METROPOLITAN GOVERNMENT OF NASHVILLE AND DAVIDSON COUNTY

STAFF RECOMMENDATION
1521 Fatherland Street
November 18, 2015

Application: New construction—infill; Setback determination
District: Lockland Springs – East End Neighborhood Conservation Zoning Overlay
Council District: 06
Map and Parcel Number: 08313040400
Applicant: John Root
Project Lead: Melissa Sajid, Melissa.sajid@nashville.gov

Description of Project: The applicant proposes to construct a new two-story house on a vacant lot. The request includes a setback determination to reduce a portion of the side setback on South 16th Street from ten feet (10') to seven feet, six inches (7' 5"). The garage shown on the site plans is not a part of the current request.

NORTH ELEVATION

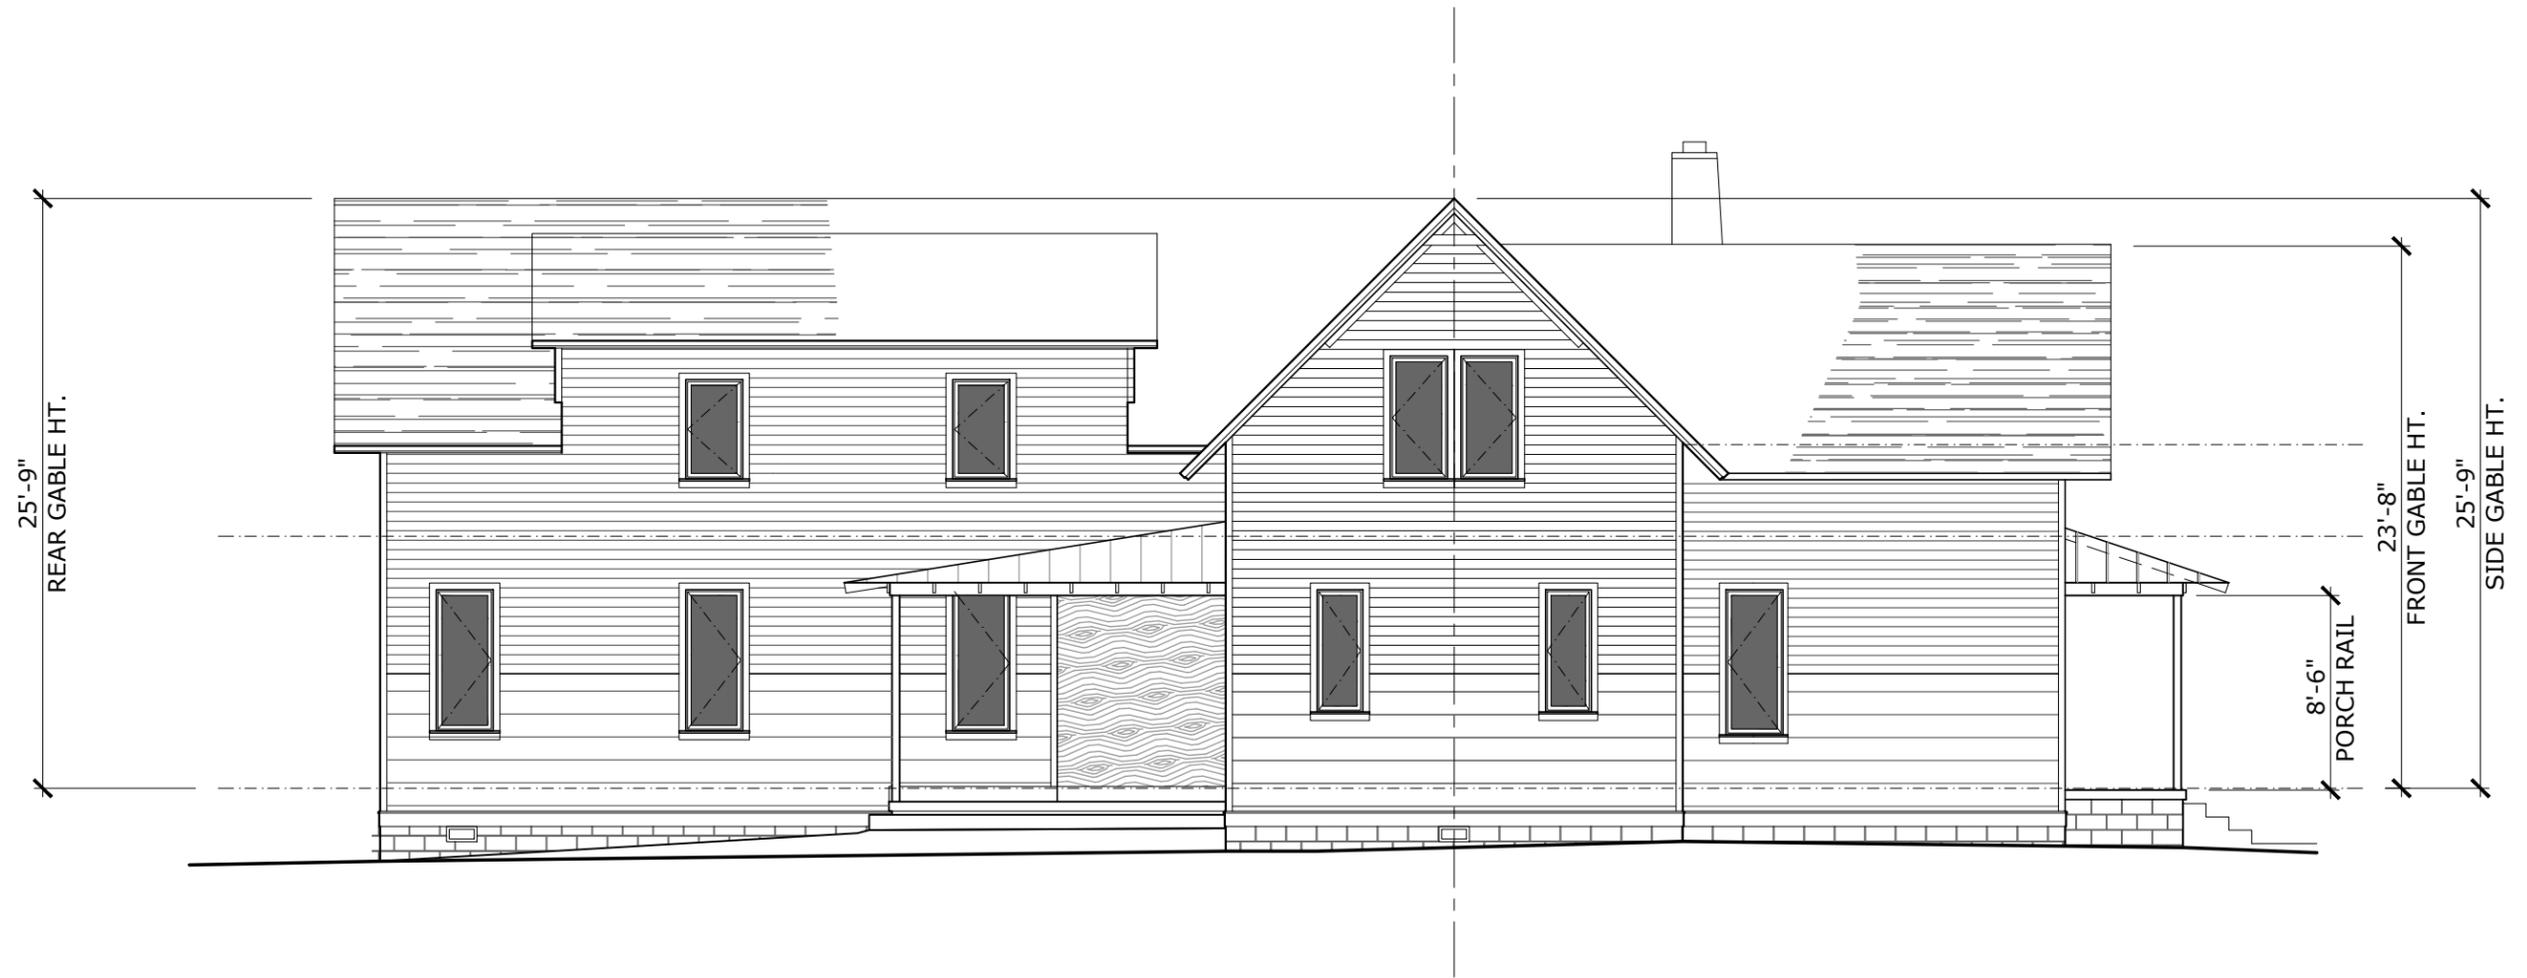
3. The siding reduction from 12" down to 4" is not consistent to the design Guidelines that is limited to 7" exposure. There is no historic evidence of this type application, and it's very unsettling visually, even if it's considered an "accent". Please stop this before there is any more allowed—again, enforcing the Guidelines.
